ATTACHMENT 1

Proposed Changes to DPR-29

Technical Specifications

QUAD CITIES
DPR-29

FIGURE 6.1-1
CORPORATE ORGANIZATION

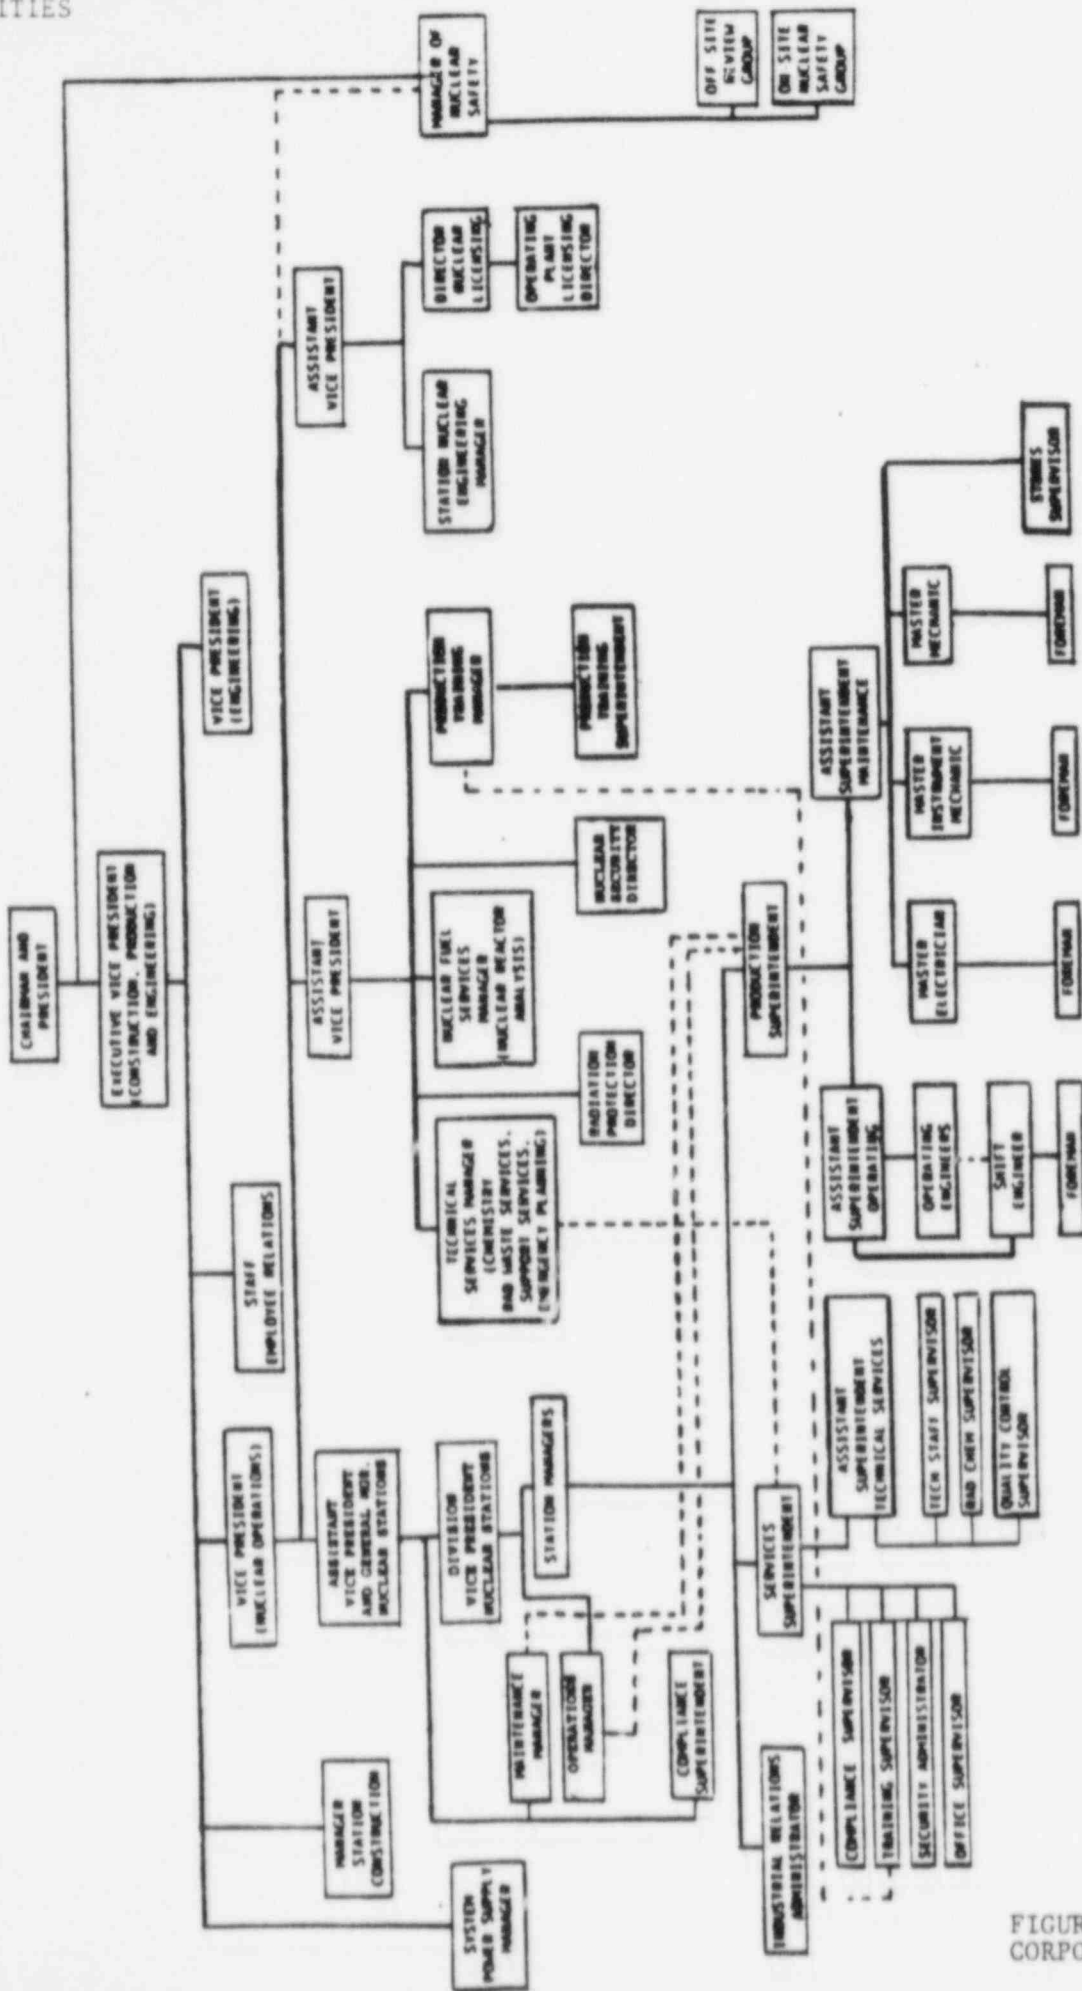
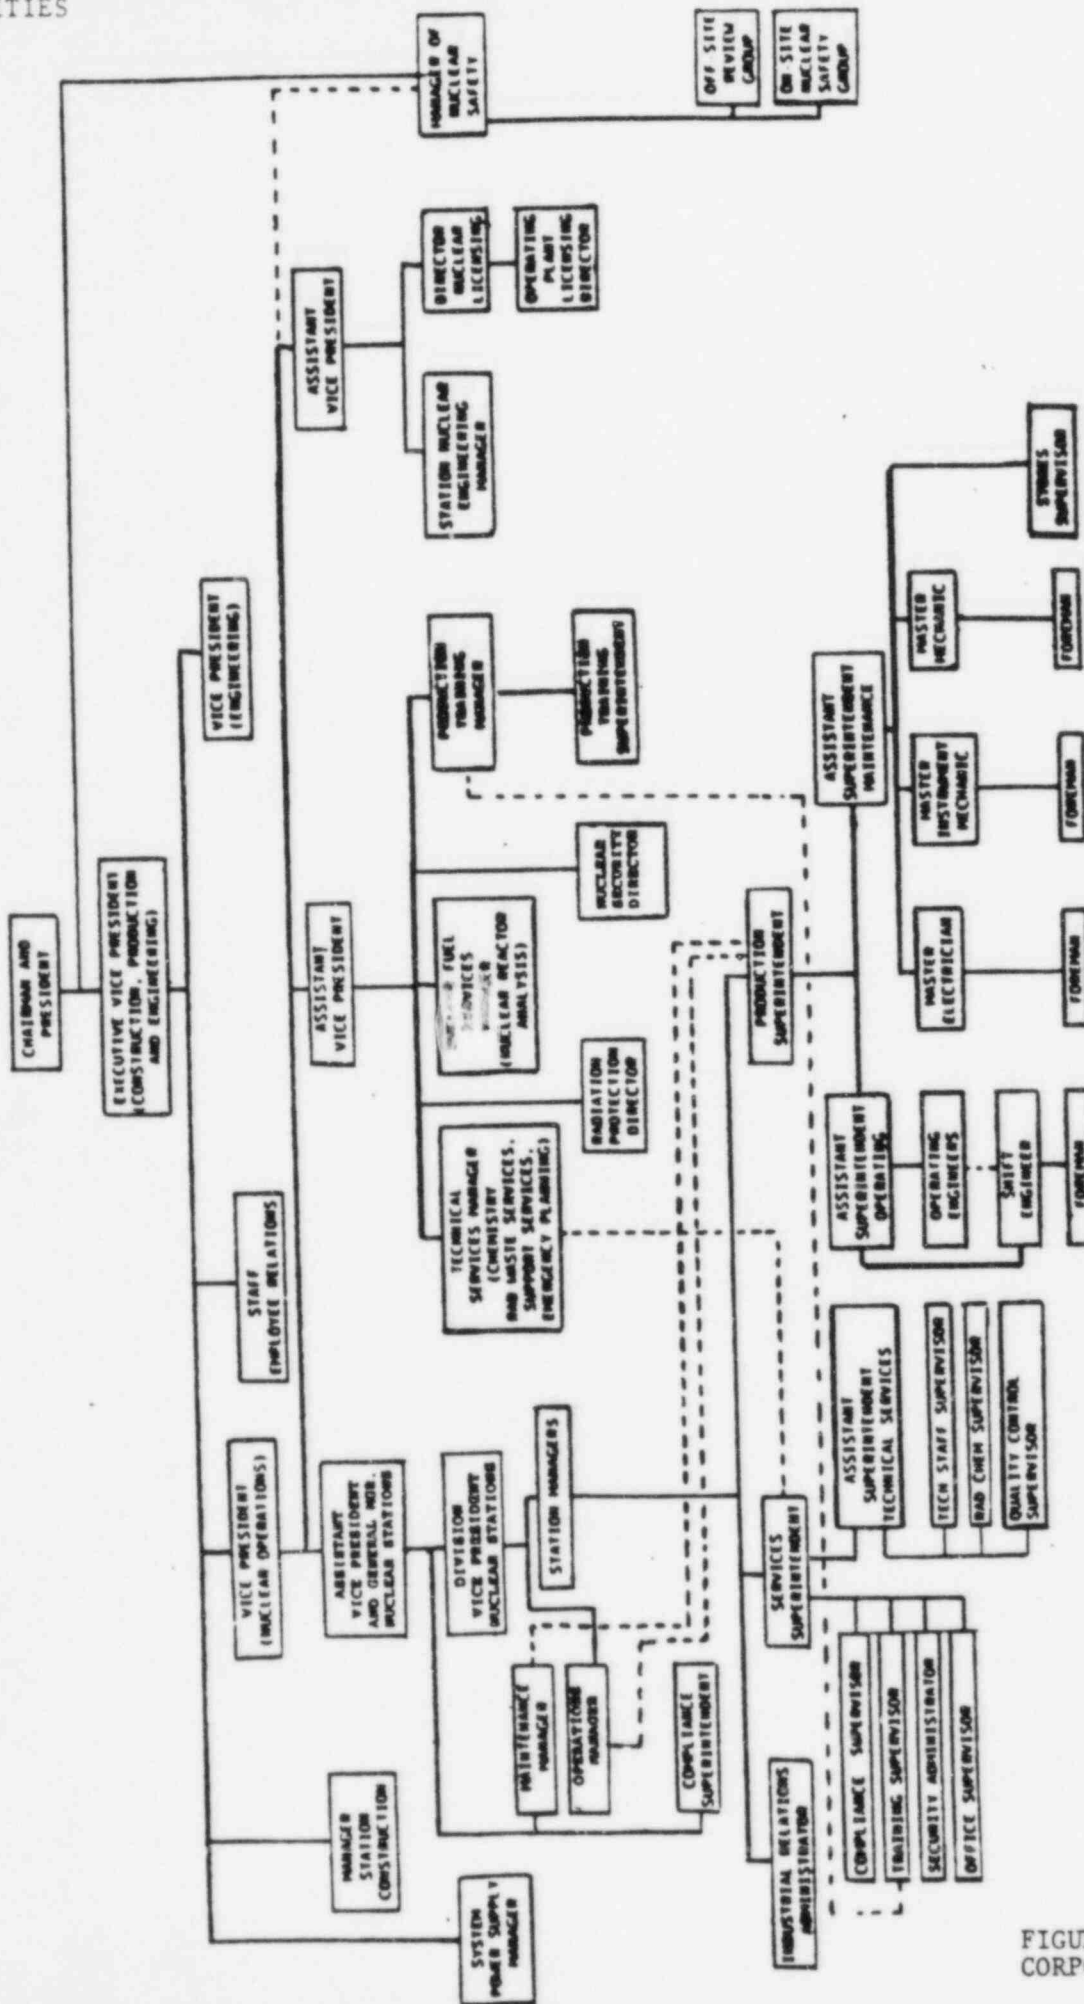
6.1-1	Title changes to reflect the revised corporate and station organization shown in new Figures 6.1-1 and 6.1-2 were made in Sections 6.1.A and C. Reference to Figures 6.1-1, 6.1-2 and 6.1-3 updated in Sections B and C. Section D - Lead Health Physicist added as alternate individual meeting the requirements of Reg. Guide 1.8 for rad protection manager. Title change to Assistant Superintendent - Technical Services. Deletion of "Station" in identifying the established Rad/Chem training program (second paragraph). Section G.1 - Supervisor of Off-Site Review now appointed by the Chairman and President.

6.1-5	Title changes in Sections 2, 2a, 2a.1, 5, 8, 9, 11.
6.1-6	Title changes in Sections b, c.1, d.1 and e.1.
Figure 6.1-1	Revised Corporate Organization Chart.
Figure 6.1-2	Revised Station Organization Chart.
Figure 6.1-3	Revised Shift Manning chart to conform with 10 CFR 50.54.m(2)(i).
6.2-1	Section 6.2.C.1, 2 - title changes and clarification of procedural approval authority.
6.3-1	Section 6.2.D.3 - title change Section 6.3.A.2 - title change.
6.4-1	Title change.
6.6-4	Title change - Regional Administrator vs Director.
6.6-5	Deletion of EGC report from Table 6.6-1 (report has been submitted).
6.7-1	Updated and more detailed description of EQ requirements.
